Re: Paric Corporation Project No. 15051
15051-Webster University Interdisciplinary Science Building
CP-052 - ASI #33 Plumbing RFIs and 02 add to HPS

Description: ASI – 033

ASI-033 is being issued for the purpose of addressing RFI # 261, 286, 309 and 310.

LEVEL 01 AREA A/B UNDER FLOOR PLAN - PLUMBING

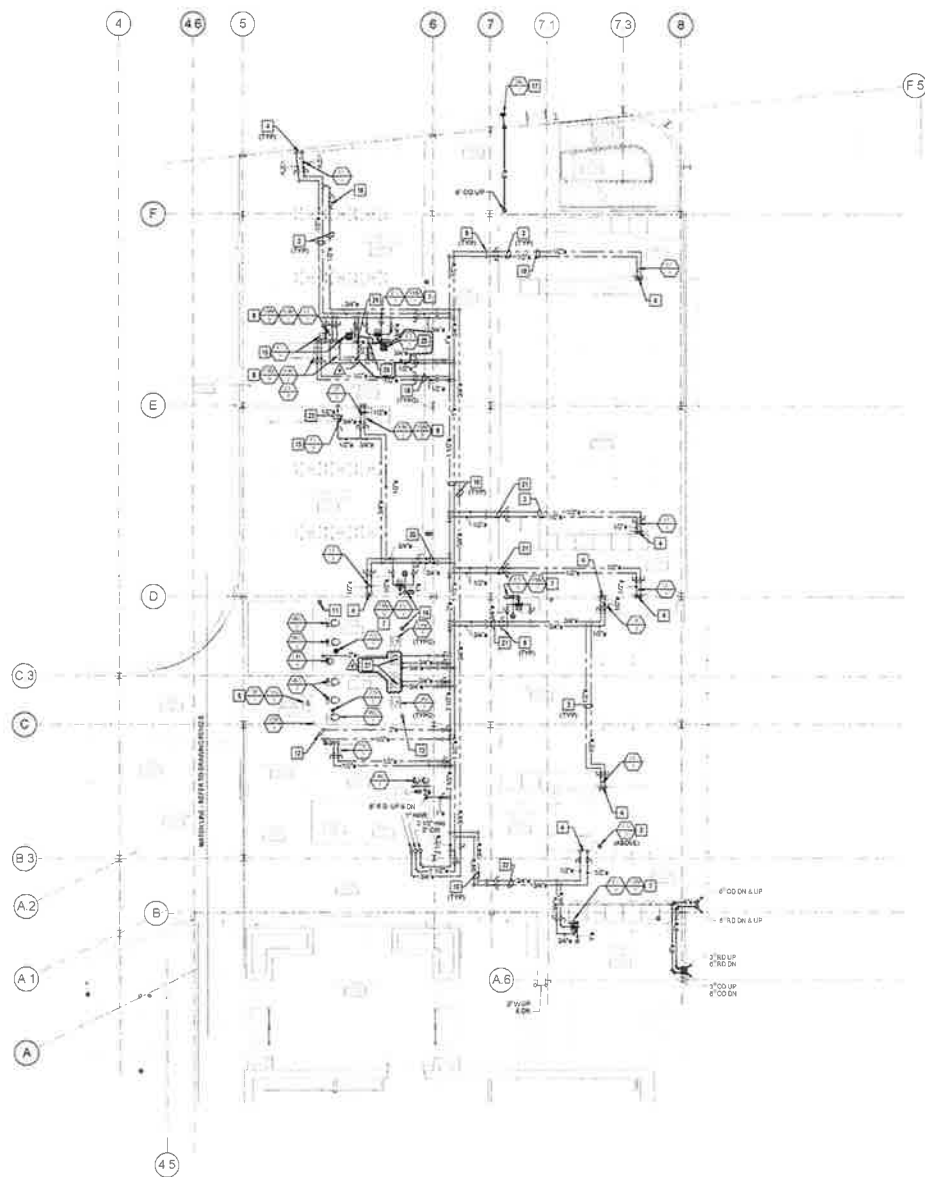
RFI-261; is requesting clarification for trap primers to the floor drains. There are five (5) different occurrences where trap primers are being required. The following is our recommendation on how to address them:

Items #2, #3, #4, and Item # 5; The Cadaver Lab #191, Receiving /Loading # 172, Mechanical Room # 178, Organics Bio Lab # 378 and Fire Pump Room # 166 will all require a water supply type trap primer, similar to PPP model P1-500/P2-500 with a or Sioux Chief model 695 with a distributor.

**LEVEL 05 ROOF PLAN
AREA B - PLUMBING**

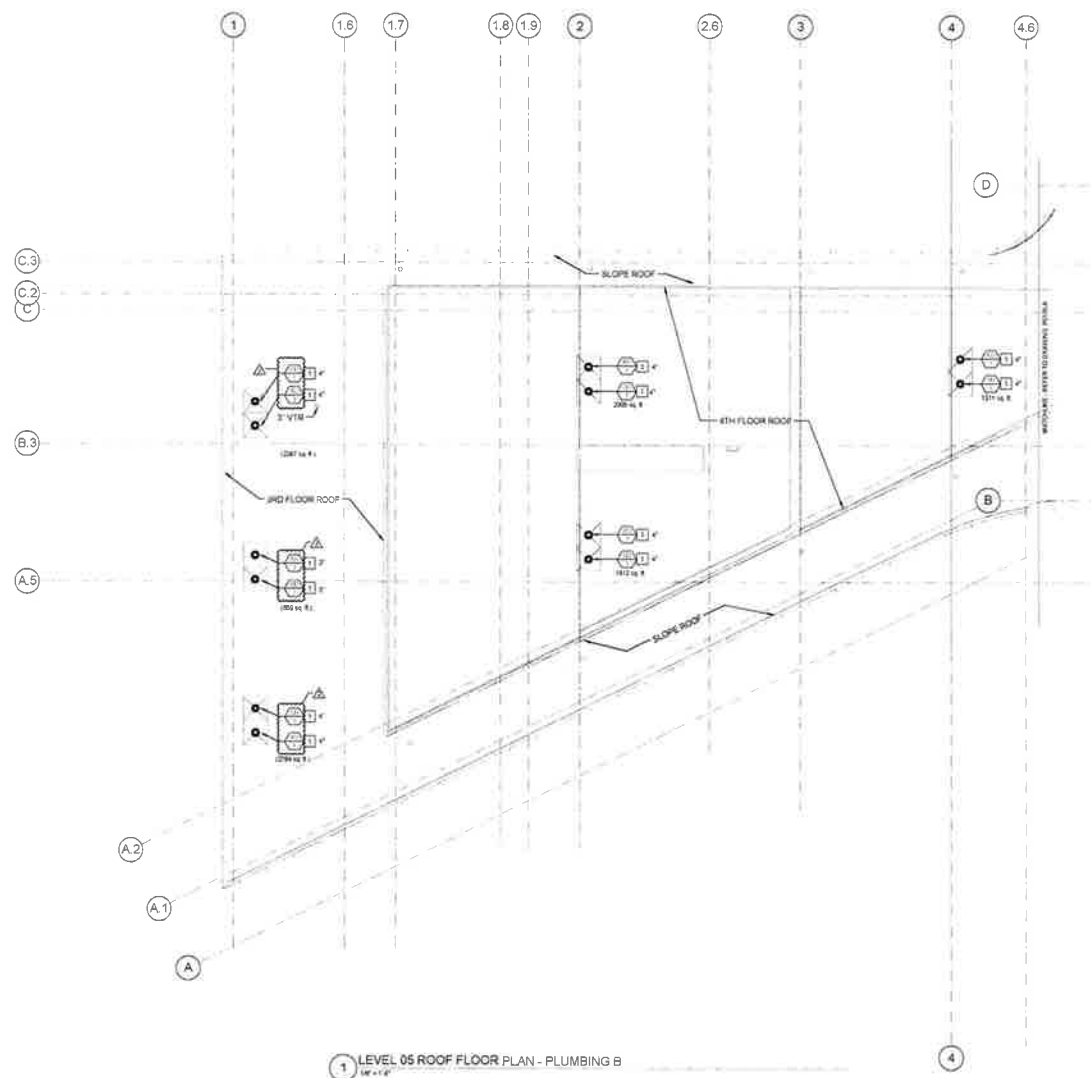
RFI-286; request a specification on the need for Overflow Roof Drains (OD-2). On sheet P0105.B, Level 05 Area B, the roof drains and overflow drains between column line 1 and column line 1.6 was miss labeled. Both the roof drain and overflow drain should have been labeled as OD-1 and RD-1. Refer to sheet P0105.B for corrections.

P0111.A

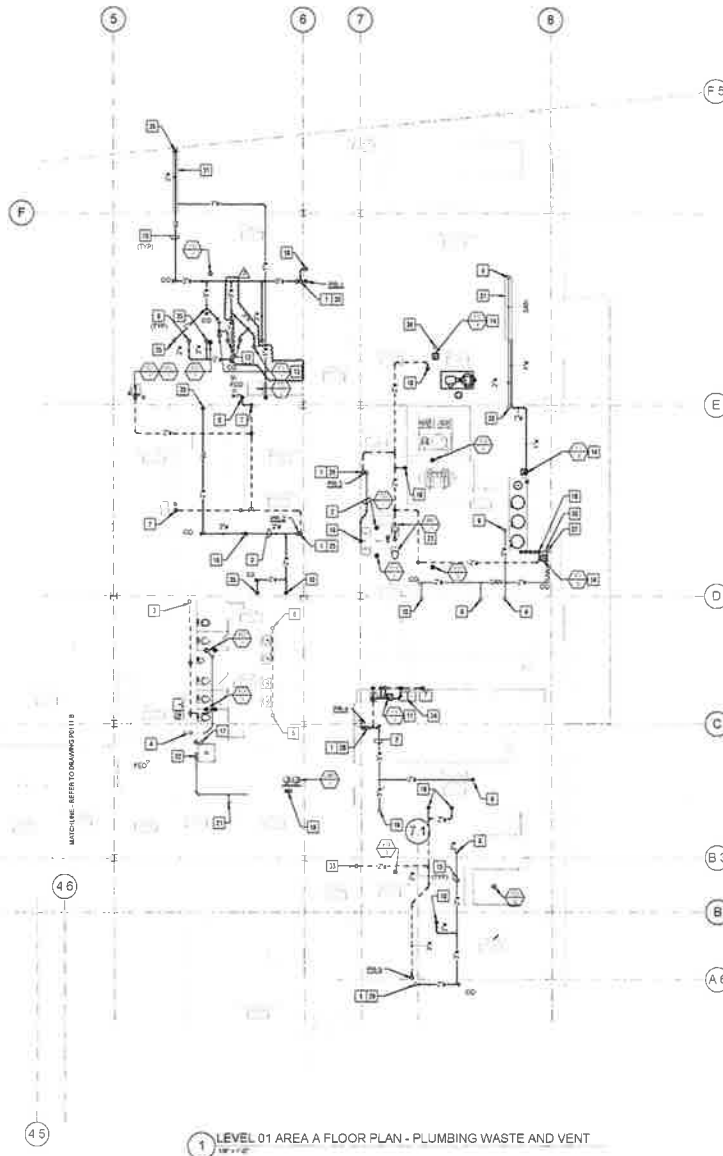
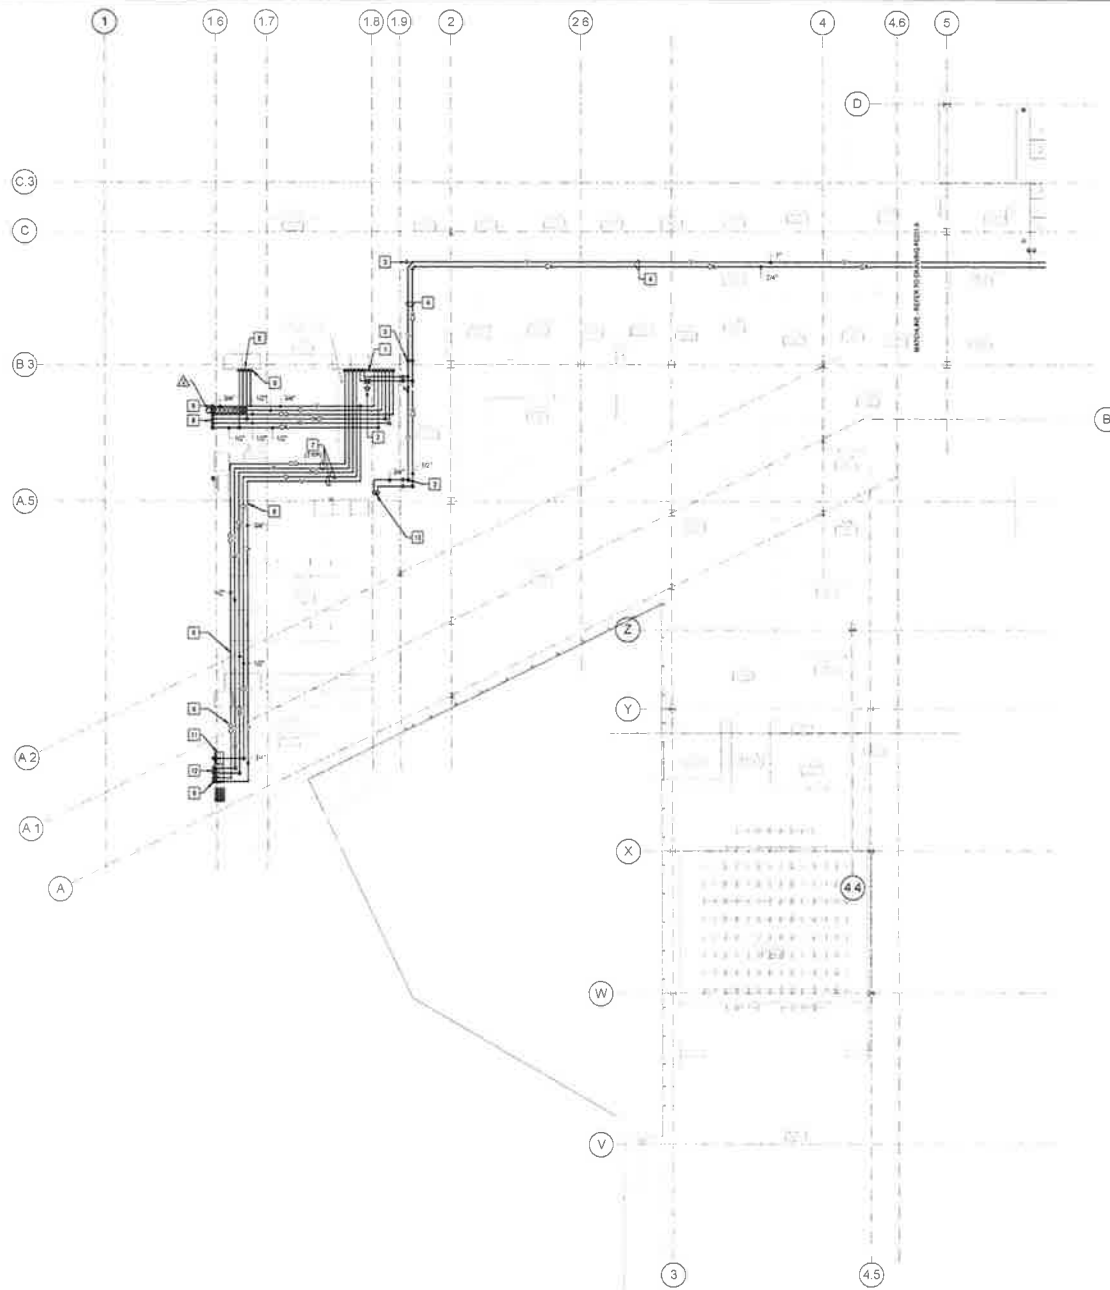
½" cold water service line down in wall has been provided for the counter top Autoclave along with a floor sink for drains. Refer to sheets P0101.A, P0102.A, P0111.A, P0112.A, P0404 and P0405 for changes.

2 TOILET ROOMS 180 AND 182 PLUMBING RISERS
P0402 SCALE NTS

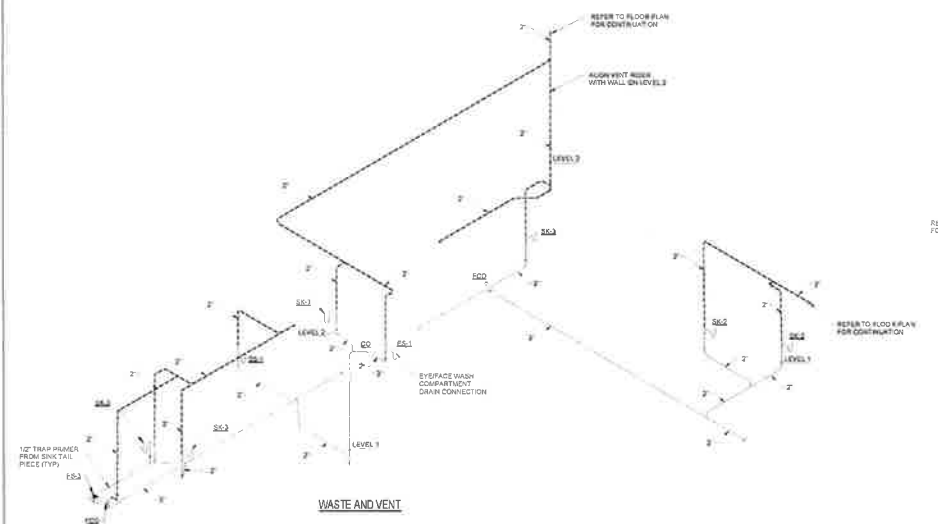
Apologies for the omission, we agree with Engineer's comment on page marked 5 about trap primers in single toilet rooms 180/182.

2. No trap primers are shown in the single toilet rooms #182 / #180. Are trap primers not wanted here ? Please advise, we priced as shown (without trap primers).

They are not included in this pricing and they are included in our base bid.

Waste Arm Trap Primers Are
Included In The Base Project.

OK. - See DeLuca
email dated 1/11/17
Agreed

5 LOADING DOCK 172 FLOOR DRAINS
P0402 SCALE NTS

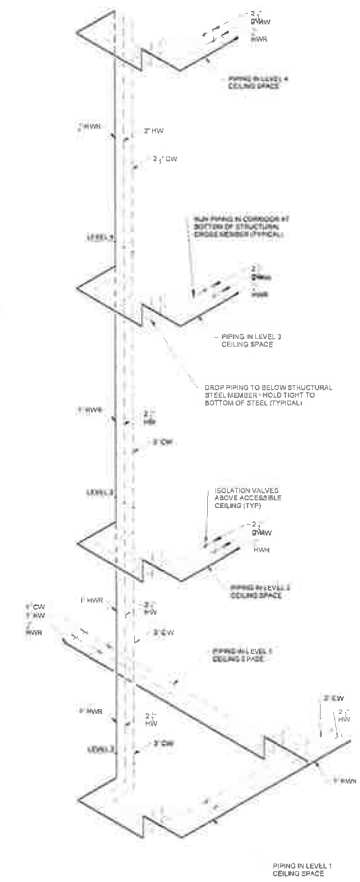
1. Trap primer serving the loading dock shows being served by the wall hydrant and we are concerned that the trap will dry out from lack of use, there is a sink at the teaching kitchen approximately 30' away. We priced it as shown, but if this change is desirable please advise.

In your pricing due today, note that the trap primer in the loading dock will be served by the sink in the teaching kitchen, which is about 30ft more underground piping. This is because the plans show the primer at a wall hydrant, which will never get used, and the trap will dry out.
